SERVICE INSTRUCTION

OIL LEAKAGES IN THE AREA OF THE CYLINDER BARREL FOR ROTAX® ENGINE TYPE 912 AND 914 (SERIES)

SI-912-019

SI-914-021

• • • • position of sealing gaskets on the left hand studs

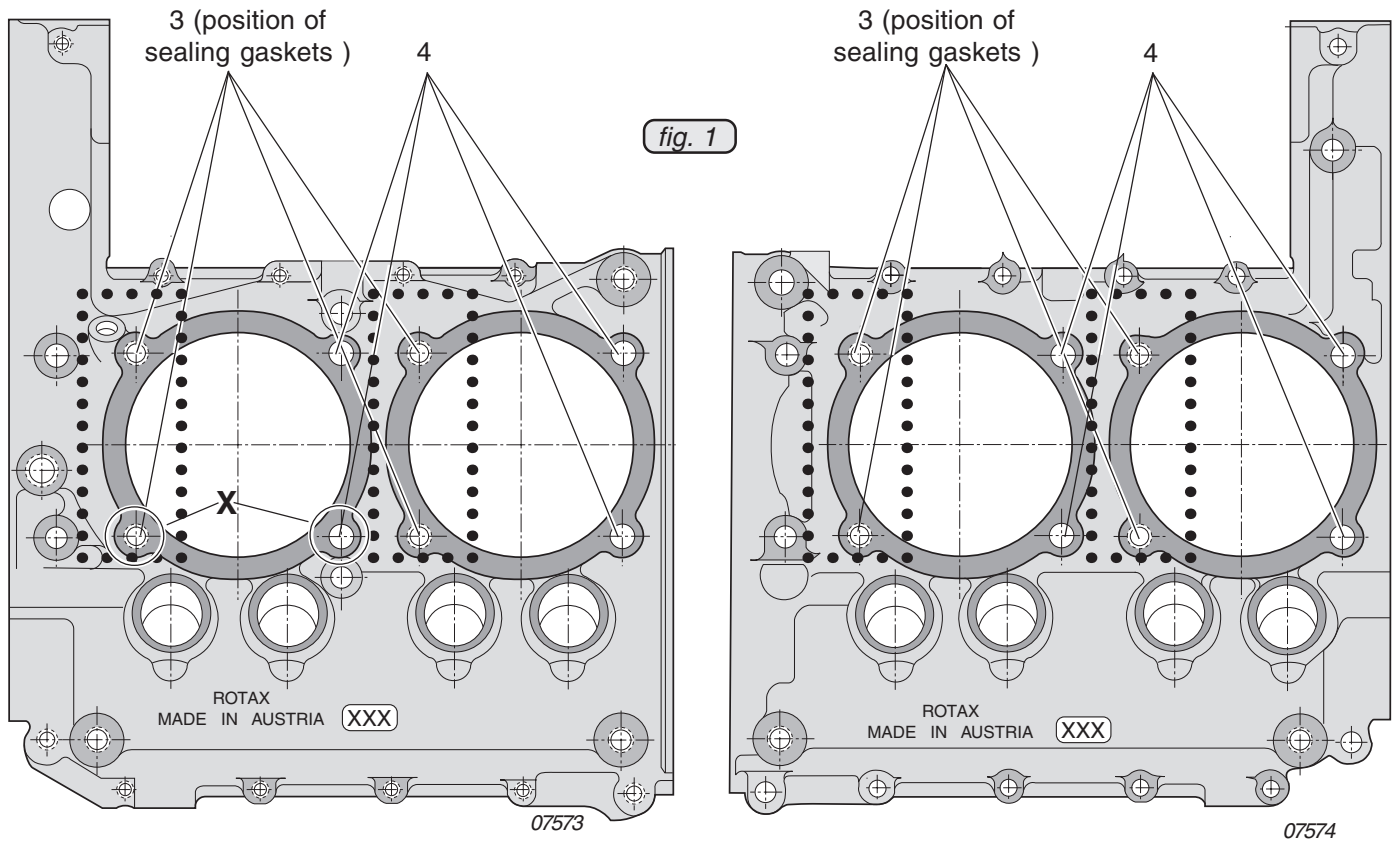
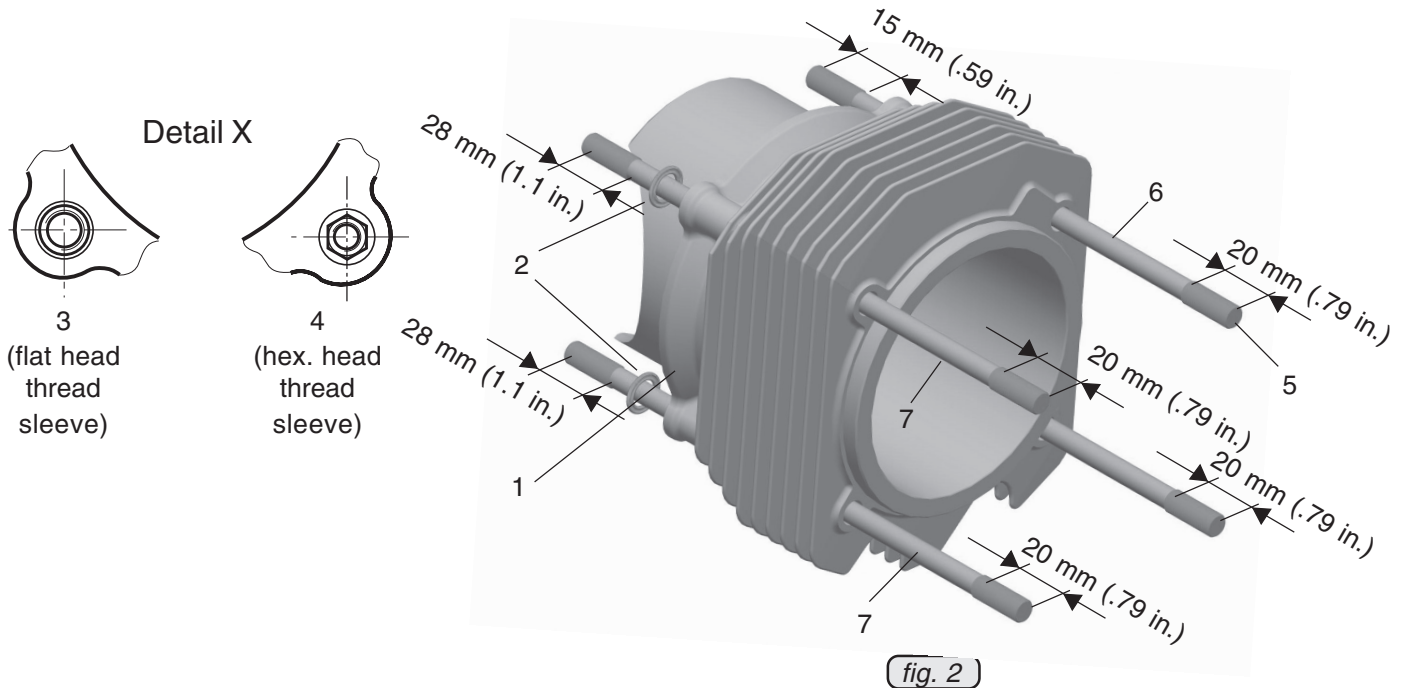
Due to deviations during assembly operation, some isolated cases of slight oil leakage in the area of the cylinder barrel have been noted. For repair purposes additional a special gasket was created which seals this area.

- in the area of the cylinder barrel (1)
- if you notice oil leaks in this area then the following work has to be performed.

- With the position still at TDC pull cylinder away from crankcase about 13 mm (1/2 in.). Do not pull out over piston rings.
- install studs (7) with thread length of 28 mm (1.10 in.) with sealing gasket (2) into positions (3) with finger tight (3 Nm) (26 in.lb.).

- ◆ NOTE: At installation of the studs obey the different thread length. Thread length 20 mm (.79 in.) (5) must point in the direction of the cylinder head.

- ◆ NOTE: Install sealing gaskets only on the 2 left hand studs (3) of each cylinder.
- install studs (6) with unequal thread length of 20 mm (.79 in.) points in the direction of the cylinder head and the short threads of 15 mm (.59 in.) go into the hex. head inserts (4) with finger tight 3 Nm (26 in.lb) (see fig. 1 and 2).
